LUSCOMBE AIRPLANE CORPORATION
West Trenton, New Jersey

ENGINEERING BULLETIN NO. 3
MODEL NO. 8

January, 1939

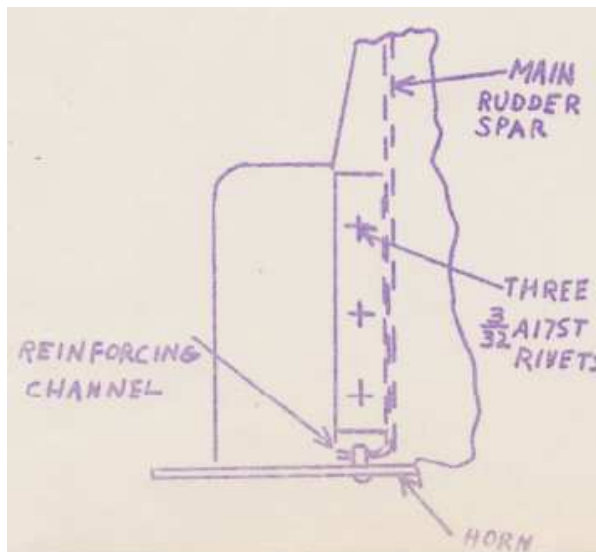
Drill through upper rudder hinge as shown and insert No. 8 steel machine screw and elastic nut. On later serial numbers this hinge bracket is tapered, and it will be necessary to substitute a bracket with straight sides which will be sent to you.

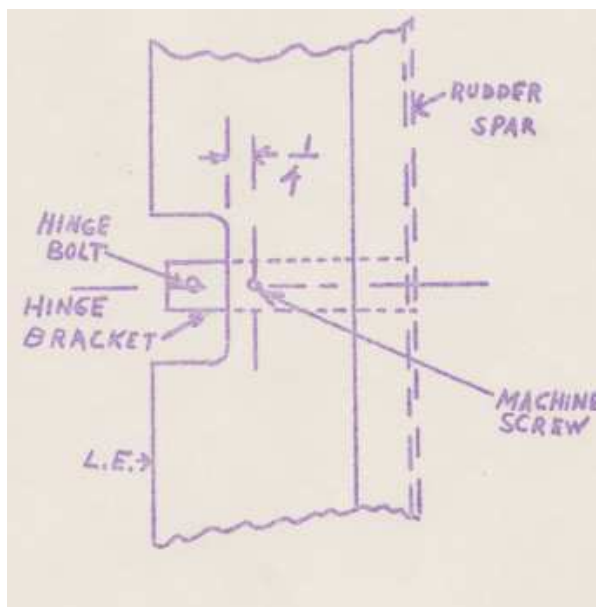
This step is necessary to relieve the lower hinge. Inspect the attachment of lower hinge and if cracks have developed in the spar or rib reinforce with .040 dural or steel channel as shown.
